AIRE APARTMENTS
CROWN PLAZA AIRE
BLOOMINGTON, MN 55425

NEW SCHEMATIC SITE PLAN

AIRE APARTMENTS
3 APPLETREE SQUARE
BLOOMINGTON, MN 55425

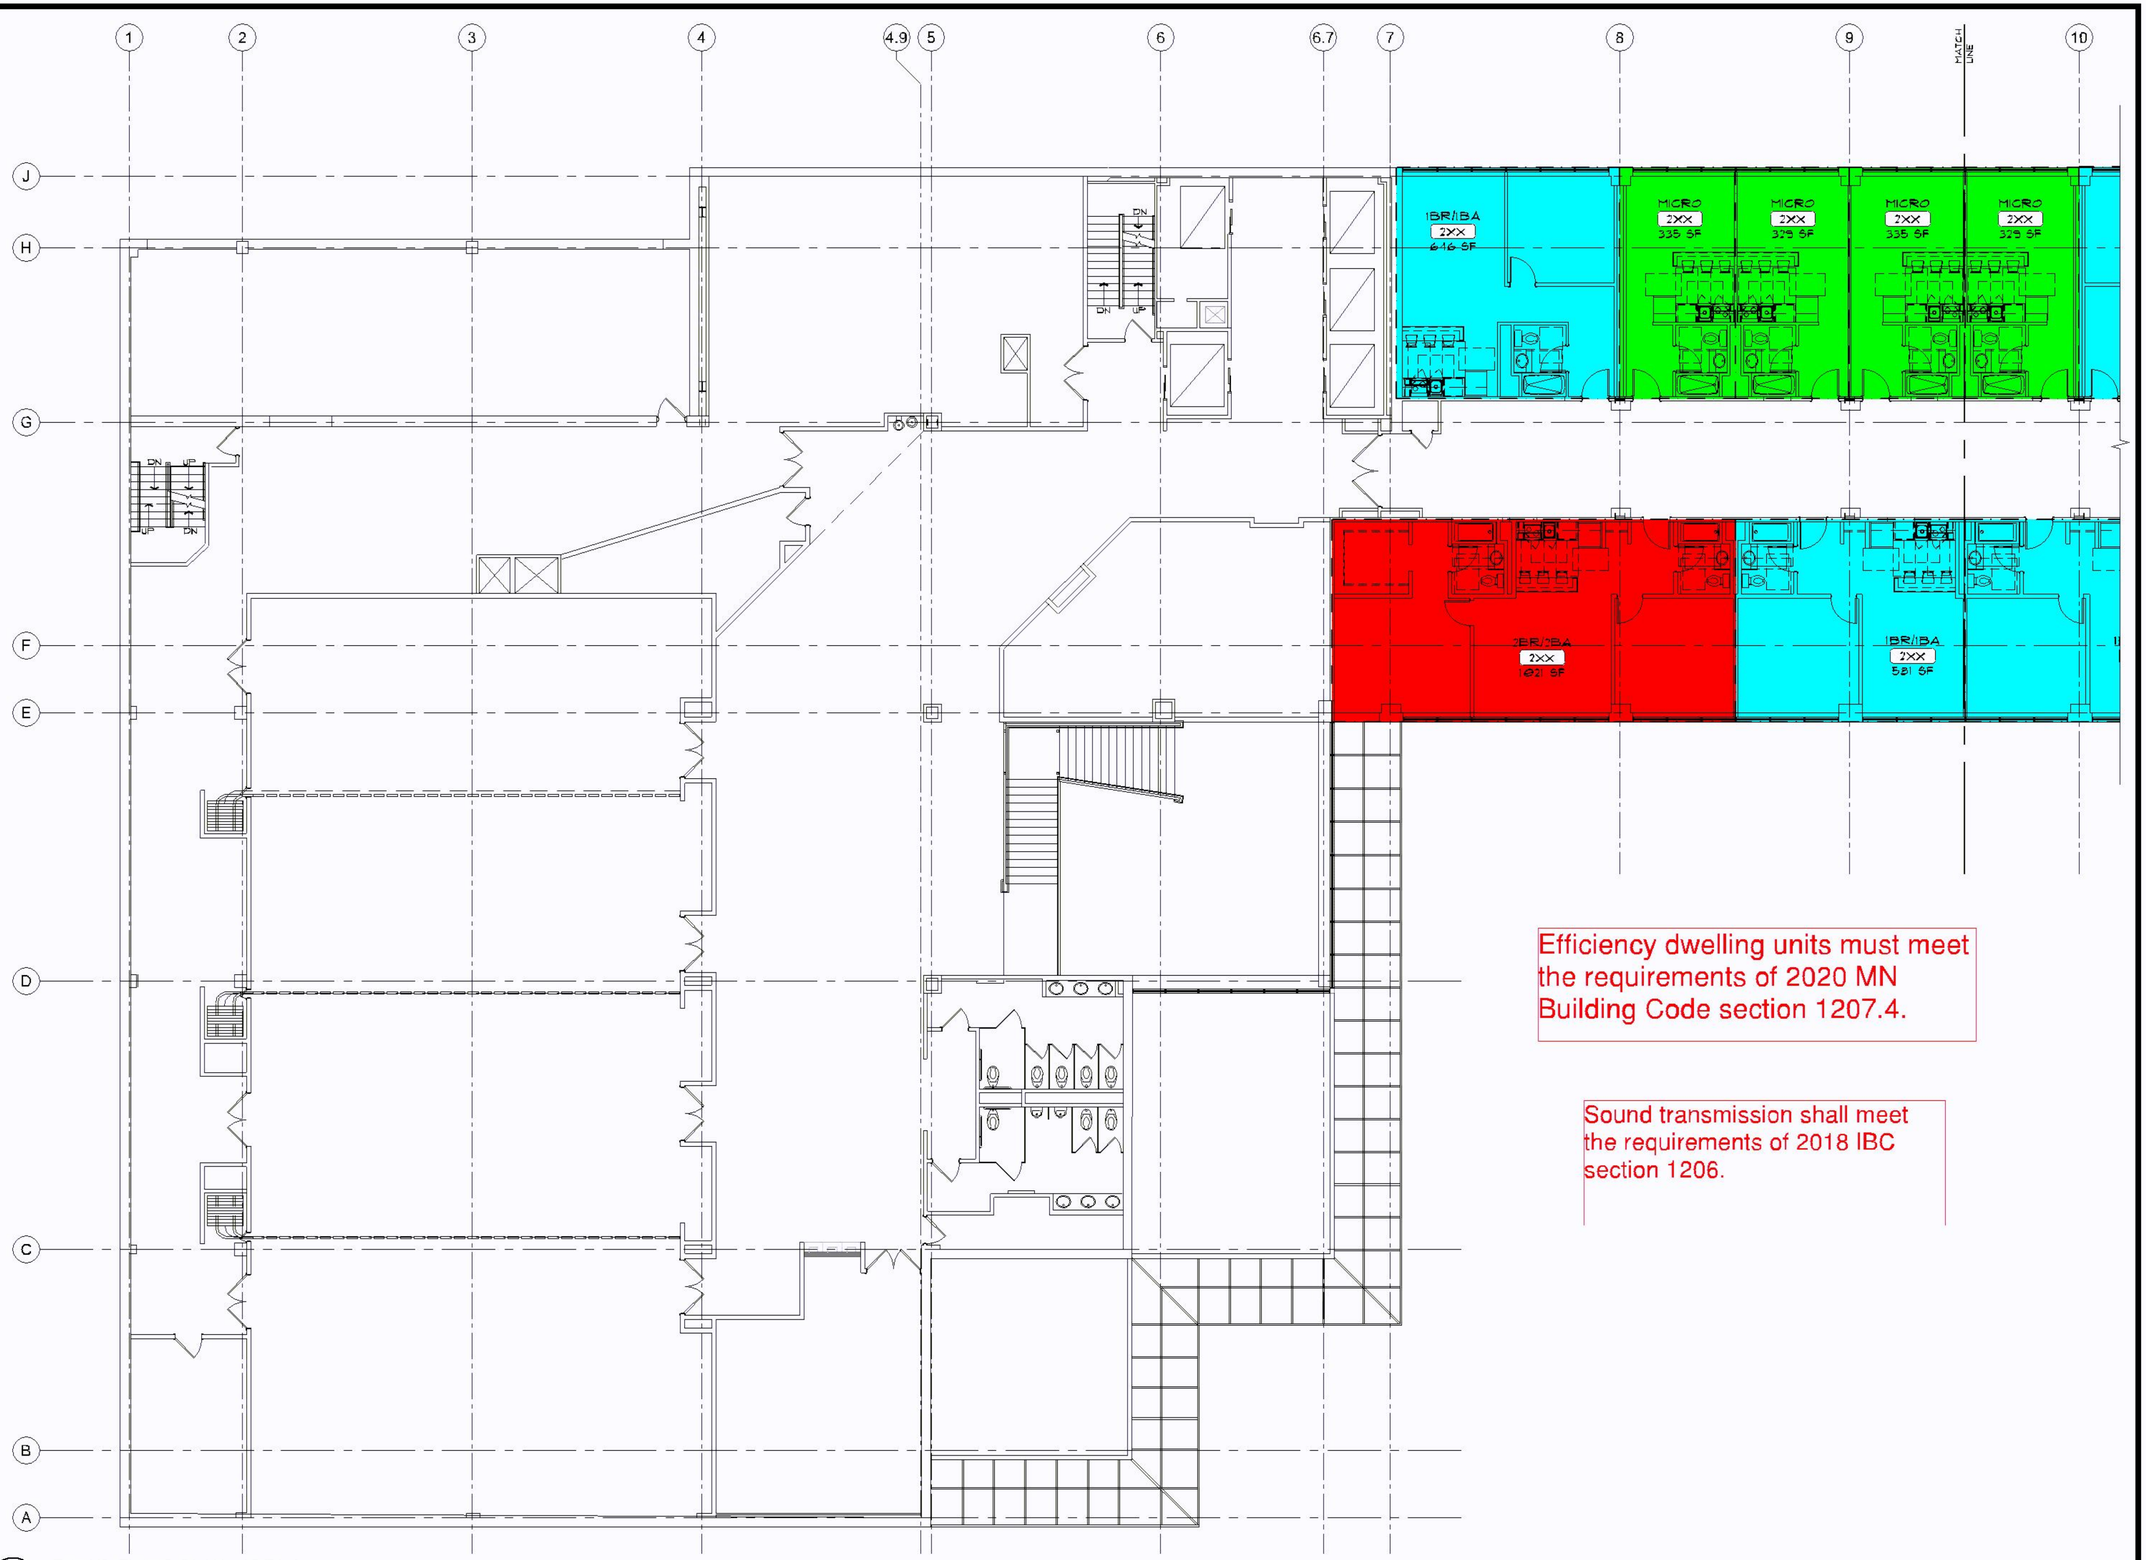
Locating mechanical equipment in front of the building on a major corner is sub-optimal. If a less visible location is not possible, a mechanical enclosure may serve as a public art opportunity.

Extend easternmost parking island to better encapsulate the parking area. Shorten mid-row island - add curb and gutter with a deciduous tree.

Extend 10-foot trail along the entirety of the new parking area.

Ensure landings do not exceed 2% in all directions

Maintain min. 2' clear zone from walk

Is a secondary pedestrian connection possible on the south end of the site?

Provide proposed parking stalls vs City code parking requirements.

SECOND FLOOR PLAN - AREA A

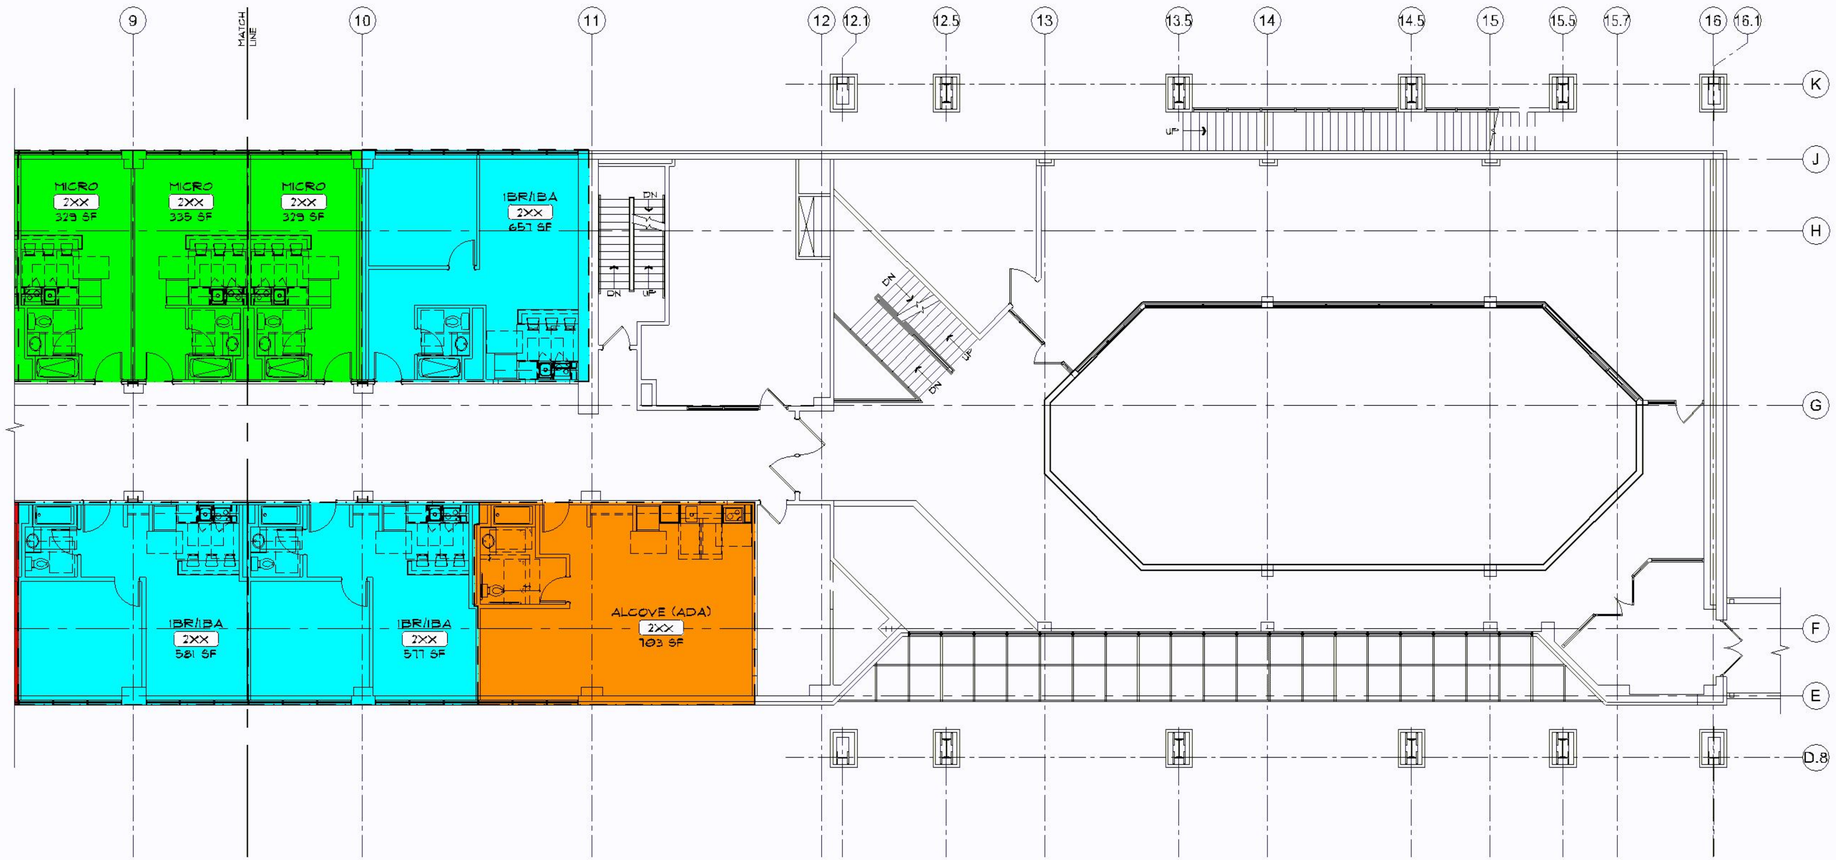
Efficiency dwelling units must meet the requirements of 2020 MN Building Code section 1207.4.

Sound transmission shall meet the requirements of 2018 IBC section 1206.

SECOND FLOOR PLAN - AREA B

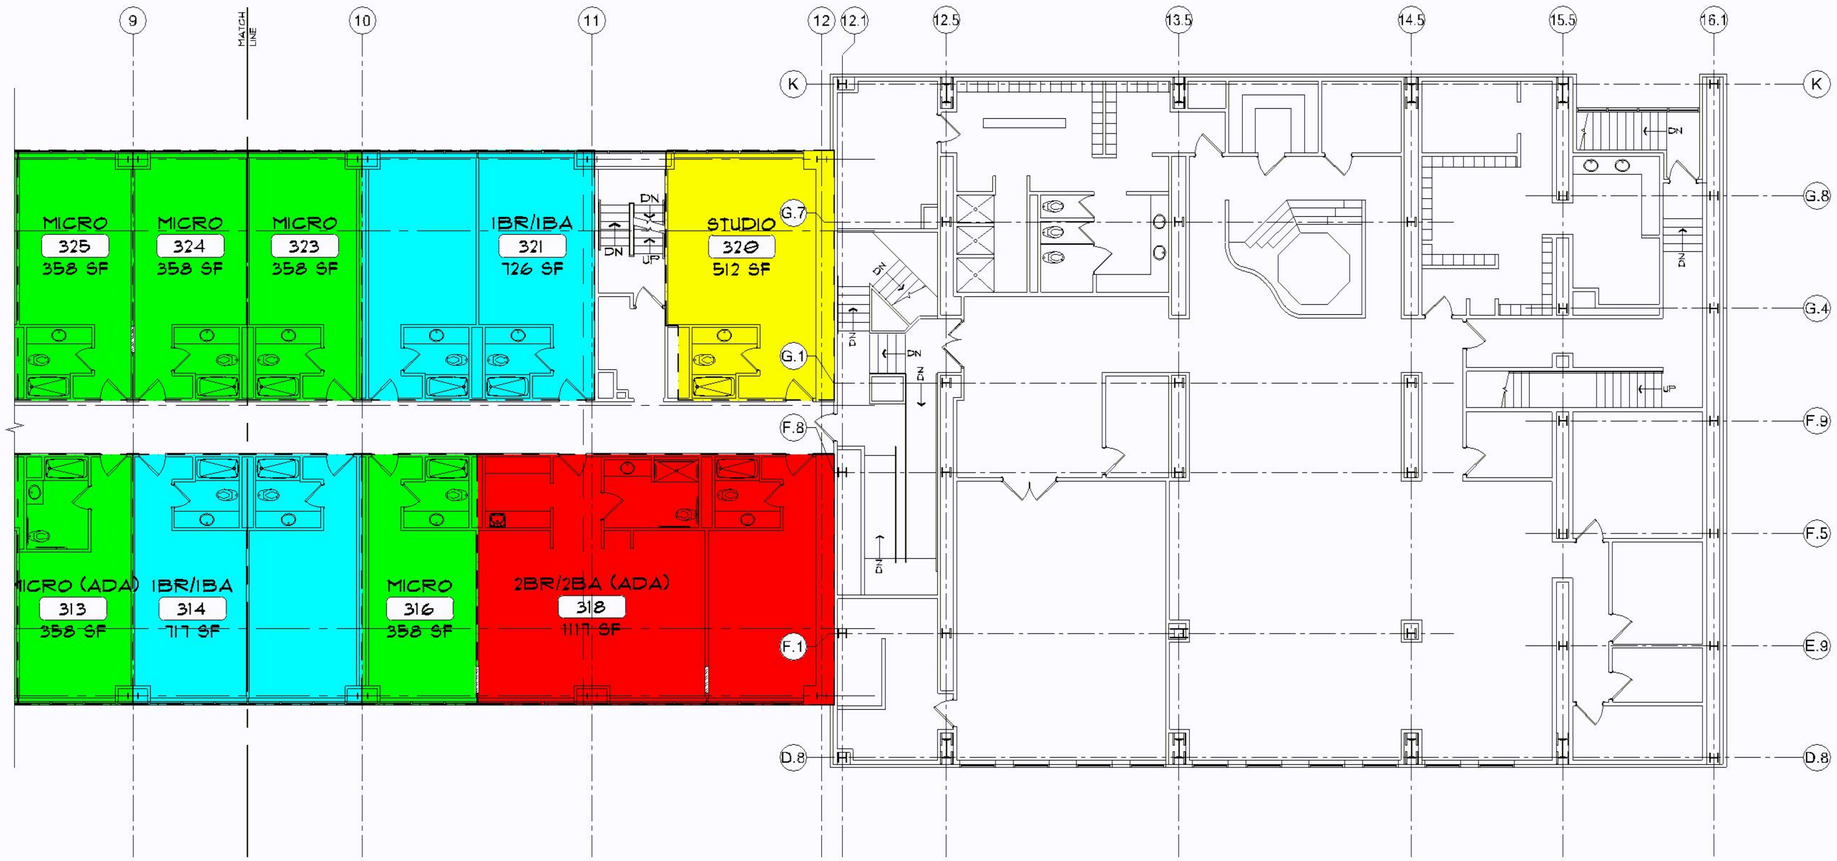
Fire alarm system to meet the requirements of the occupancy determined by the building code for all areas including the commercial and residential upgrades.

All required smoke and CO detection shall be code compliant including the replacement of detectors 10 years or older.

Emergency responder radio coverage meeting the requirements of appendix L in the 2015 MSFC shall be provided throughout the property and within the structures.

Building/property shall be adequately signed for emergency response.
